STAFF RECOMMENDATION

NCPC File No. 6558

**GSA HEADQUARTERS
BUILDING MODERNIZATION**
(Including Options for Perimeter Security, E Street Entrance, and Ground Floor Retail)

1800 F Street NW
Washington, DC

Portion of proposed perimeter security plan showing bollards placed at curb along E and 18th Streets

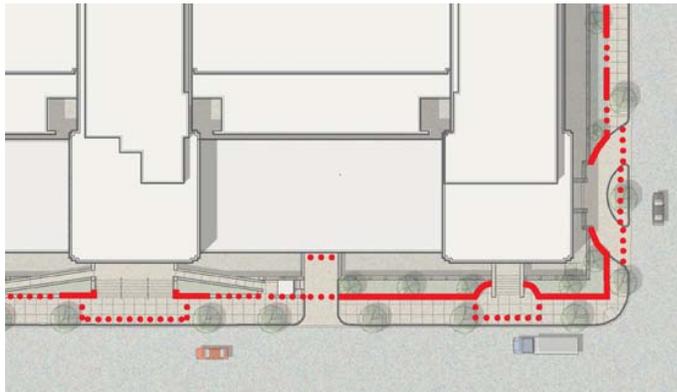
Staff has analyzed the proposed perimeter security concept plan and finds that it complies with NCPC’s Urban Design and Security Plan Objectives and Policies. Adopted by the Commission in May 2005, these objectives and policies are intended to address important city planning and design issues in instances where it is necessary to construct physical perimeter security in urban areas, and are intended to balance the need for perimeter security with the need to protect public space by keeping it

open, accessible and attractive. Despite being less than 20 feet wide, GSA has proposed to locate a substantial majority of the perimeter security elements within the existing building yard with the exception of those elements located at two entrances along E Street, and one entrance along 18th Street. The design of the security barriers has been integrated into the project site through the use of a combination of security elements and hardening of existing landscape features. Although overall the proposed plan meets NCPC’s objectives and policies pertaining to the design and placement of perimeter security, the bollards located at the curblines have the potential to impede upon pedestrian access and circulation. **Staff recommends that GSA continue to consult with NCPC staff and other interested stakeholders on the proposed perimeter security plan, and specifically on the design and placement of security elements at the building entrances along E Street NW and 18th Street NW**

Recommends that GSA continue to consult with NCPC staff and other interested stakeholders on the proposed perimeter security plan, and specifically on the design and placement of security elements at the building entrances along E Street NW and 18th Street NW.
